Nitric Acid Production Project Protocol

Version 1.0

ERRATA AND CLARIFICATIONS

3. Figure 4.1 (ERRATUM – March 17, 2011)

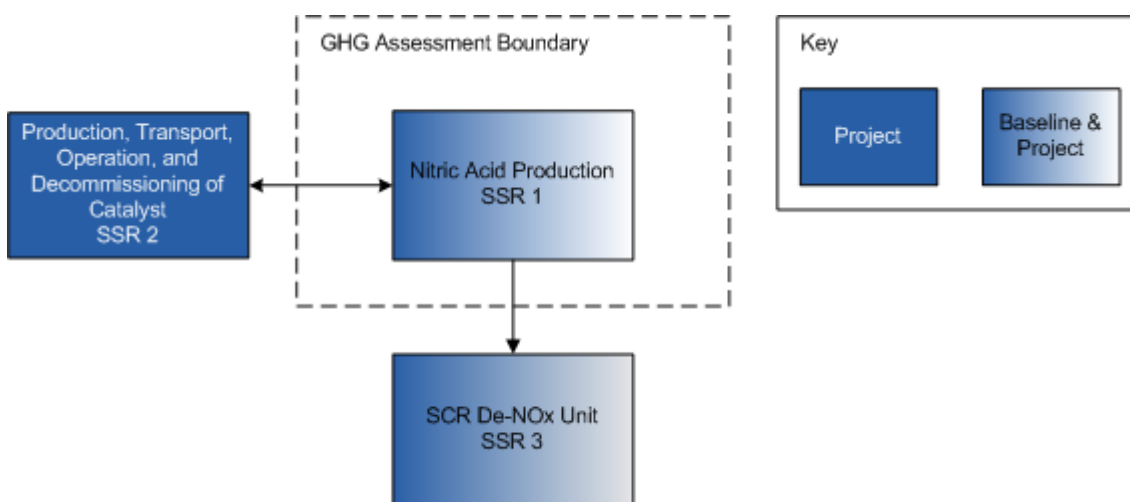
Context: Figure 4.1 provides a general illustration of the GHG Assessment Boundary for secondary catalyst projects, indicating which SSRs are included or excluded from the boundary. It includes SSR 3 – SCR De-NO_x Unit within the boundary, while the corresponding Table 4.1 correctly excludes SSR 3 from the boundary.

Correction: SSR 3 – SCR De-NO_x Unit was erroneously included within the boundary in Figure 4.1. SSR 3 should be excluded from the GHG Assessment Boundary in Figure 4.1, making it consistent with Table 4.1. The effect of SCR de-NO_x technology on N₂O emissions is not only small, but also equivalent in the baseline and project. The corrected Figure 4.1 appears below.

4. Figure 4.2 (ERRATUM – March 17, 2011)

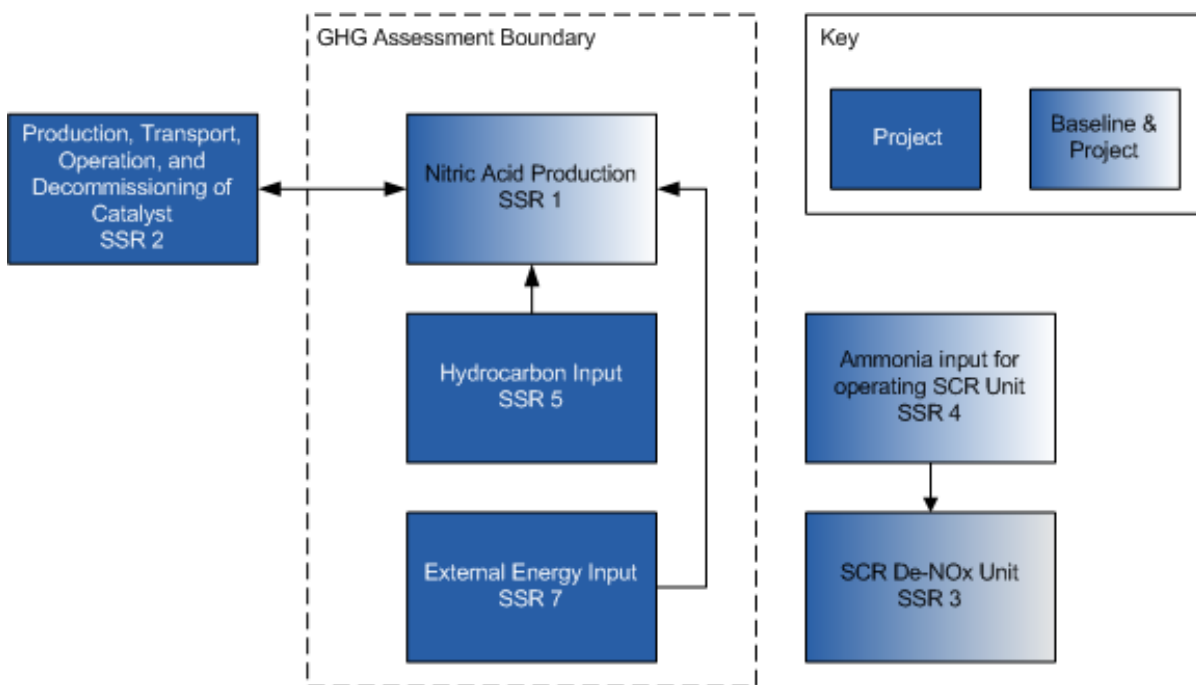
Context: Figure 4.2 provides an illustration of the GHG Assessment Boundary for tertiary catalyst projects with existing SCR De-NO_x units operating prior to the project start date, indicating which SSRs are included or excluded from the boundary. It includes SSR 3 – SCR De-NO_x Unit within the boundary, while the corresponding Table 4.2 correctly excludes SSR 3 from the boundary.

Correction: SSR 3 – SCR De-NO_x Unit was erroneously included within the boundary in Figure 4.2. SSR 3 should be excluded from the GHG Assessment Boundary in Figure 4.2, making it consistent with Table 4.2. The effect of SCR de-NO_x technology on N₂O emissions is not only small, but also equivalent in the baseline and project. The corrected Figure 4.2 appears below.

5. Figure 4.3 (ERRATUM – March 17, 2011)

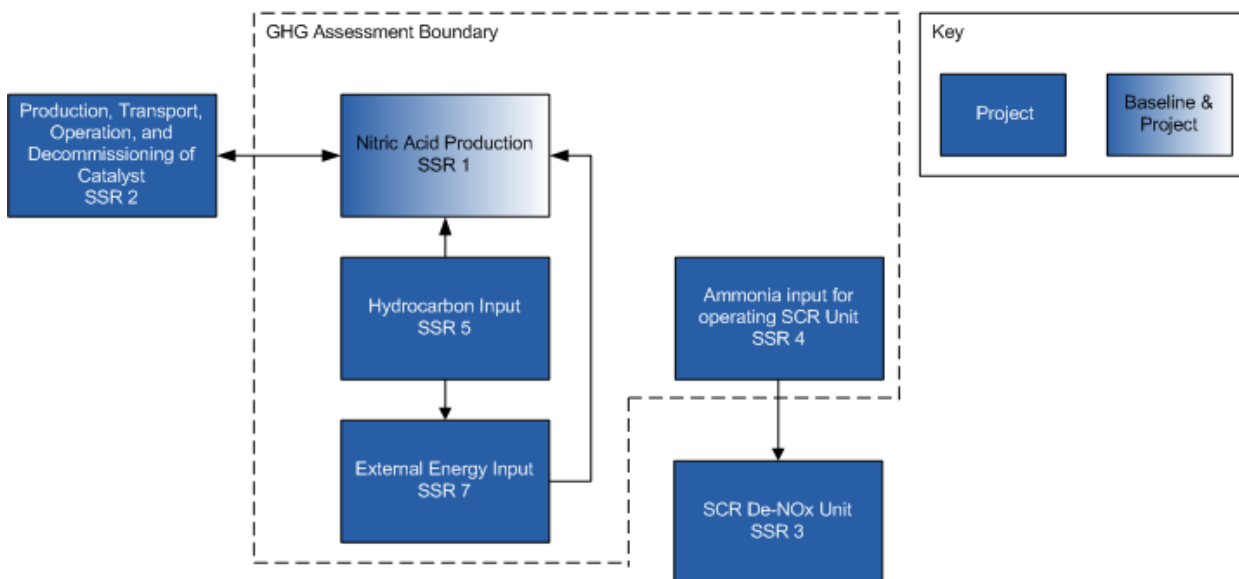
Context: Figure 4.3 provides an illustration of the GHG Assessment Boundary for tertiary catalyst projects without existing SCR De-NOx units operating prior to the project start date, indicating which SSRs are included or excluded from the boundary. It includes SSR 3 – SCR De-NOx Unit within the boundary, while the corresponding Table 4.2 correctly excludes SSR 3 from the boundary. The effect of SCR de-NOx technology on N₂O emissions is assumed to be minimal and therefore not necessary to include. Additionally, SSR 3 and SSR 4 – Ammonia Input for operating SCR Unit are both erroneously shaded to indicate emissions are relevant in both the baseline and the project.

Correction: SSR 3 – SCR De-NOx Unit was erroneously included within the boundary in Figure 4.3. SSR 3 should be excluded from the GHG Assessment Boundary in Figure 4.3, making it consistent with Table 4.2. In addition, SSR 3 and SSR 4 should both be colored solid blue, to indicate that emissions from these sources are only relevant in the project. The SCR de-NOx unit and the ammonia used to operate it are added in conjunction with the tertiary catalyst, and are therefore not present in the baseline. The corrected Figure 4.3 appears below.
